The Polk County UTILITIES CODE COMMITTEE is charged with updating the seven REFERENCE MANUALS associated with Ordinance 10-081 (AKA: Utilities Code). In accordance with Section 11: Utilities Code Committee and Section 12: Reference Manual Revision Procedure, the UTILITIES CODE COMMITTEE recommends approval of revisions to portions of the following reference manuals:

- **Utilities Standards and Specifications Manual (6B)**
 - **Table of Contents**
 - Add references to SCADA sections approved in April 2013
 - **Chapter Four (4): Potable Water**
 - Approved Materials Checklist
 - Automatic Combination Air/Vacuum Release Valves, Butterfly Valves (Val-Matic)
 - **Chapter Five (5): Wastewater**
 - Section 512: Wastewater Lift Station Design Standards
 - Wastewater Approved Materials Checklist
 - Material – Concrete (Atlantic TNG, Allied Precast)
 - Standard Drawings (WW-01-1, WW-05-1, WW-05-2, WW-06-2)
 - **Chapter Six (6): Reclaimed Water**
 - Approved Materials Checklist
 - Automatic Combination Air/Vacuum Release Valves, Butterfly Valves (Val-Matic)

PRECAST CONCRETE MANHOLE (TYPICAL)

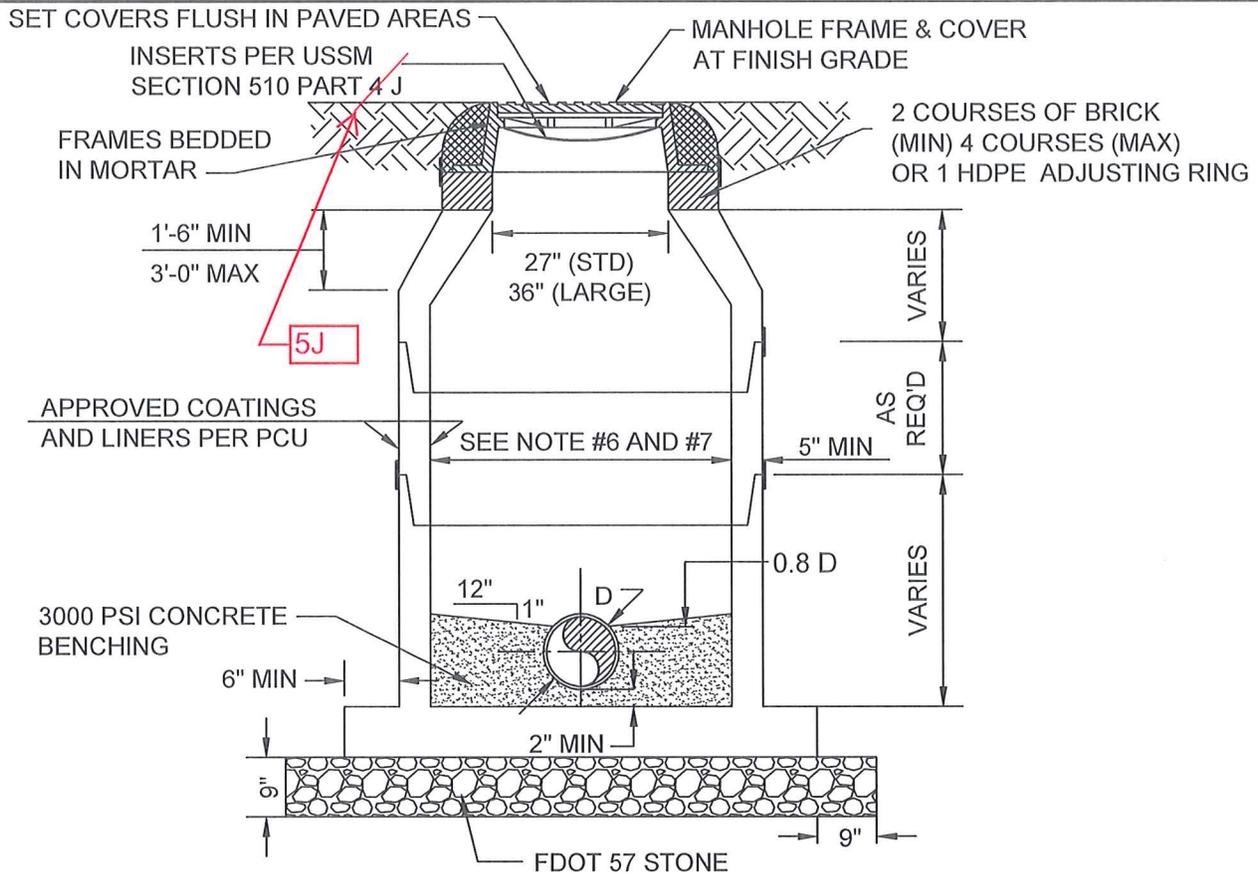
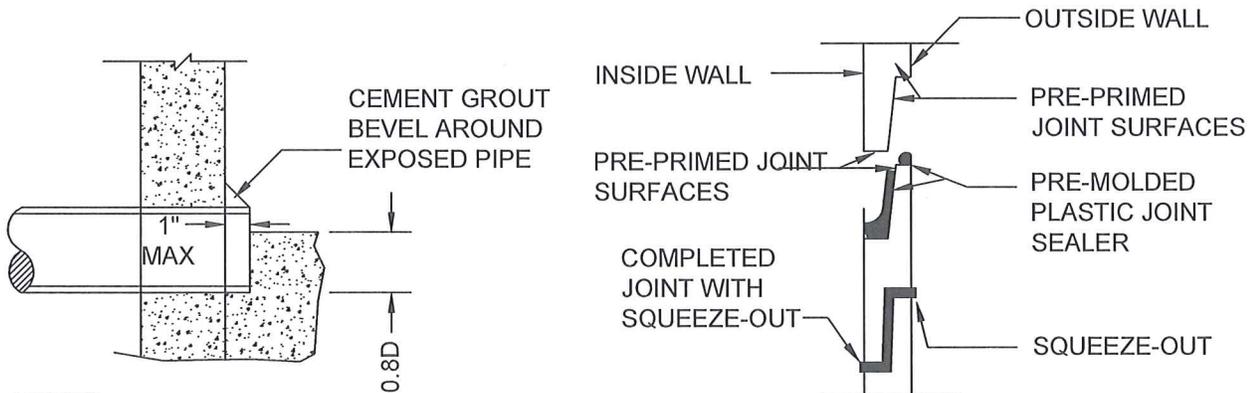
NOTES:

1. INTERIOR DROP CONNECTIONS ARE REQUIRED WHENEVER THE INVERT OF THE INFLUENT SEWER IS 24" OR MORE ABOVE THE INVERT OF THE MANHOLE. THE DIAMETER OF THE DROP MANHOLE SHALL BE 5'-0".
2. ECCENTRIC CONE DESIGN MAY BE USED AS AN ALTERNATIVE, AS APPROVED.
3. A FLOW CHANNEL SHALL BE CONSTRUCTED INSIDE MANHOLE TO DIRECT INFLUENT INTO FLOW STREAM.
4. LIFT HOLES THROUGH STRUCTURE ARE NOT PERMITTED.
5. HDPE ADJUSTING RINGS MAY BE SUBSTITUTED FOR BRICK RISERS.
6. MASTER MANHOLES SHALL BE 5'-0" DIAMETER.
7. MANHOLE DIAMETER SHALL BE 4'-0" MIN FOR MAINS 8" TO 24" (STD), 5'-0" MIN FOR MAINS 24" TO 36" AND 6'-0" MIN FOR SEWER 36" AND LARGER..

**FIGURE
WW-01-1**

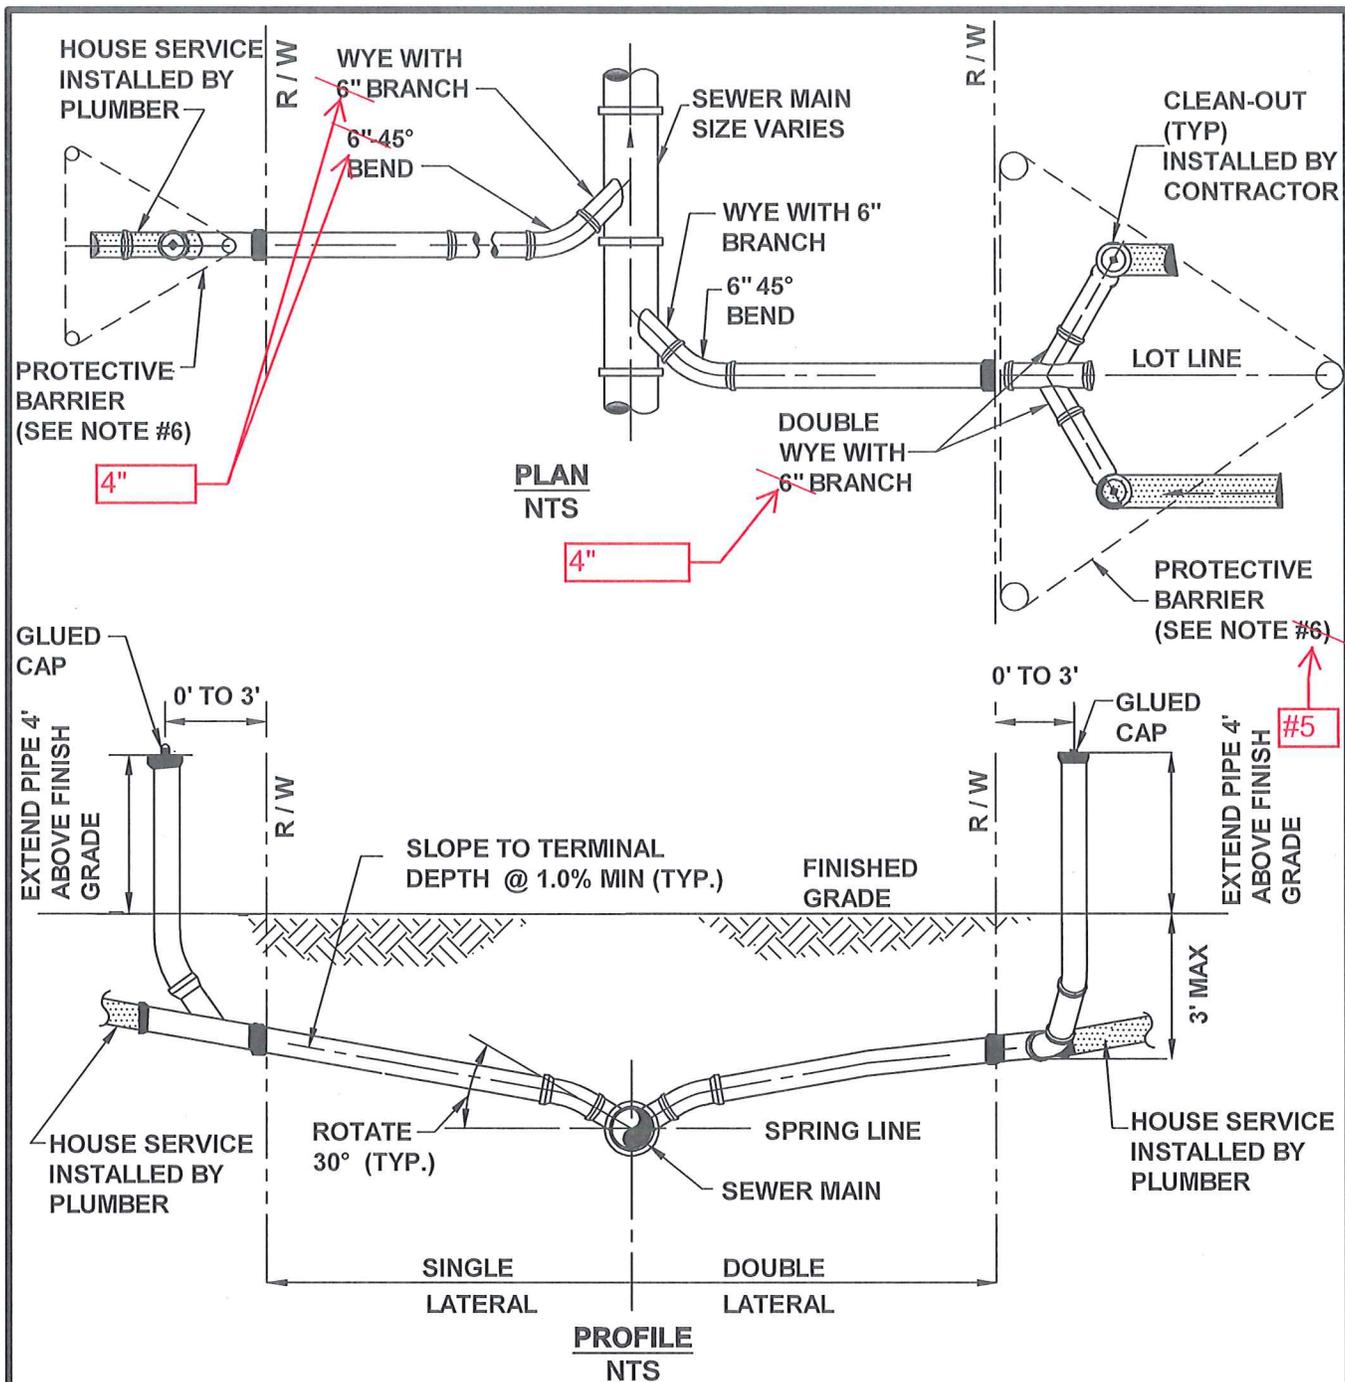
NOTES:

1. INVERT OF SERVICE LATERAL SHALL NOT ENTER SEWER MAIN BELOW SPRING LINE.
2. SERVICE LATERAL CLEAN OUT PIPE SHALL BE EXTENDED AND CAPPED BY CONTRACTOR.
3. ALL FITTINGS SHOWN ARE TO BE INSTALLED.
4. BUILDER'S PLUMBER WILL REMOVE PLUG, ADJUST CLEAN OUT PIPE TO GRADE, AND CONNECT SERVICE LATERAL TO HOUSE.
5. PROTECTIVE BARRIER TO BE 3-2" x4" or 2" POLES w/ WITH RED CONSTRUCTION WARNING FENCE OR TAPE.

FIGURE
WW-5-2

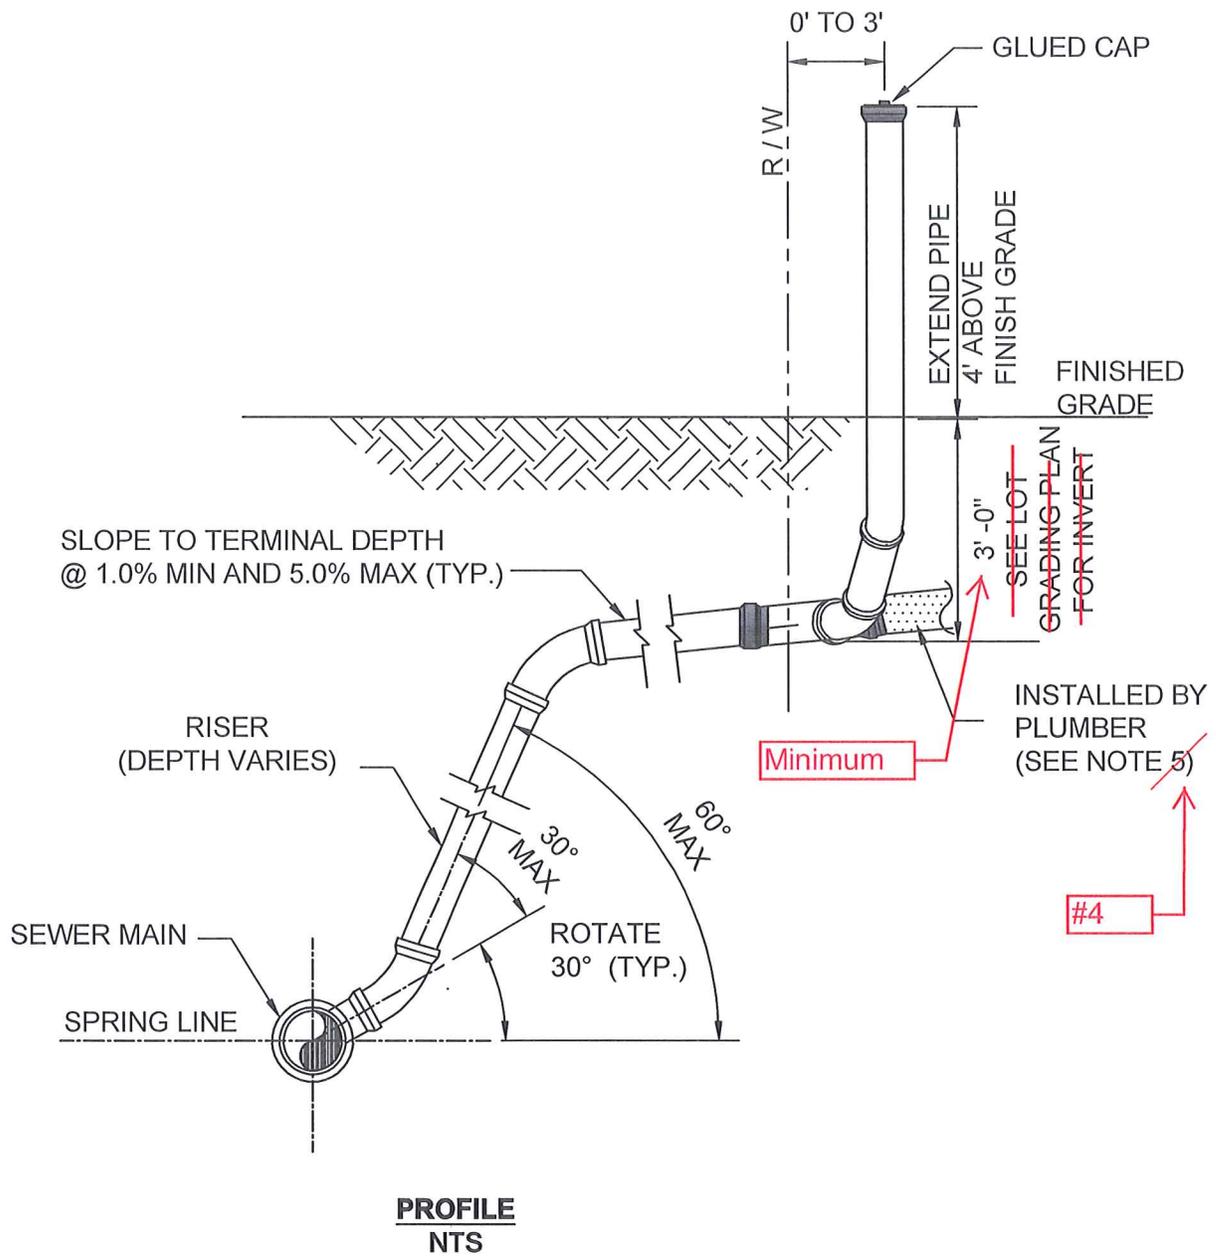
NOTES:

1. INVERT OF SERVICE LATERAL SHALL NOT ENTER SEWER MAIN BELOW SPRING LINE.
2. SERVICE LATERAL CLEAN-OUT PIPE SHALL BE EXTENDED AND CAPPED BY CONTRACTOR.
3. ALL FITTINGS SHOWN ARE TO BE INSTALLED.
4. BUILDER'S PLUMBER WILL REMOVE PLUG, ADJUST CLEAN-OUT PIPE TO GRADE, AND CONNECT SERVICE LATERAL TO HOUSE.

**FIGURE
WW-06-2**
~~AUGUST, 2013~~

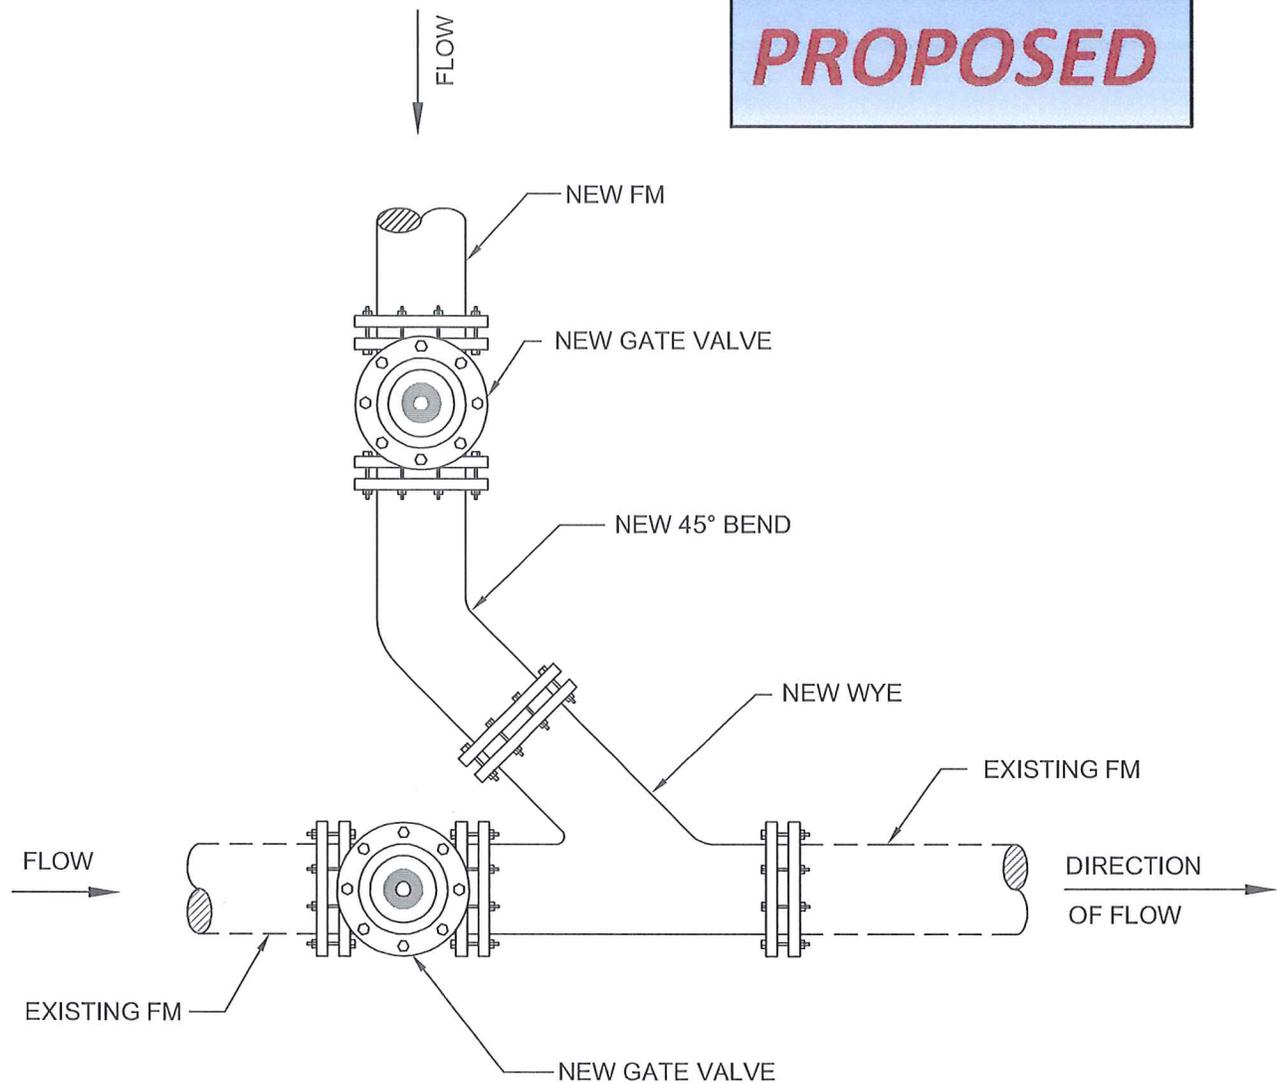
NOTES:

- 1. ALL JOINTS (INCLUDING JOINTS ON EXISTING MAINS) SHALL BE RESTRAINED IN ACCORDANCE WITH USSM CHAPTER 3. ENGINEER SHALL VERIFY DESIGN ASSUMPTIONS AND INCREASE RESTRAINED LENGTHS AS REQUIRED.
